CCC Audit - Urban Residential & other Buildings (BCCCC_Res)

NotesBC230758175 TOWNSEND ROAD RANGIORA LOT 115

Re:PS4 Construction Review at Lot 115 Townsend Fields – Building Consent BCN 230578 (HFC Job #23-135)

Date	04-Dec-2023	Time	13:47
Address	Lot 155, Stage 3, Townsend Fields, Rangiora		
Inspection Carried Out By Group:	HFC: Civil and Structural Sth Ltd		
Pre-pour Inspection			
HFC JOB NUMBER:	23-135		
BC NUMBER:	230578		
WEATHER:	Overcast		
WIND:	Gentle		
CONTRACTOR:	John Baddock		
INSPECTOR:	Sithum Jayatilleke		
EMAIL RECIPIENTS:	john.baddock@outlook.com		
Next Inspection	No further inspections by HFC		
REPORT STATUS:	OK TO PROCEED SUBJECT TO INCORPORATION OF NOTES

View of F1 detail

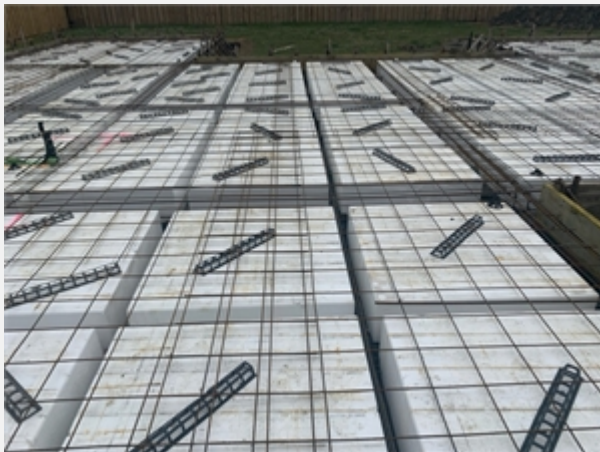
Contractor to maintain 30-40mm top cover to mesh.

Contractor confirmed to have replaced pod rails with standard mesh chairs G25/40 - photos received

View of excavation for F3 detail (600x600mm)

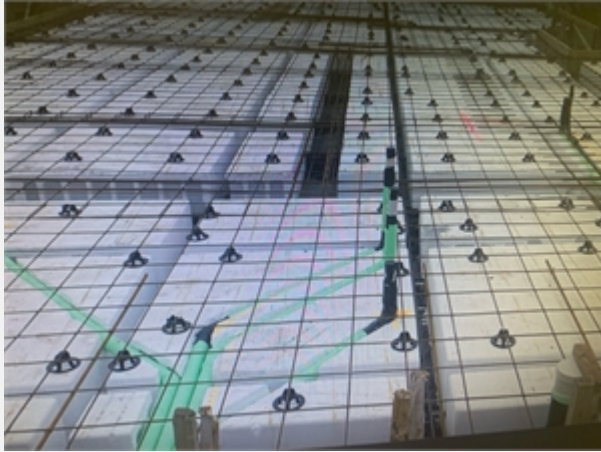
View of reinforcement detail for F3 detail - U bars each

F3 detail - Contractor photos received - 14/01/2024
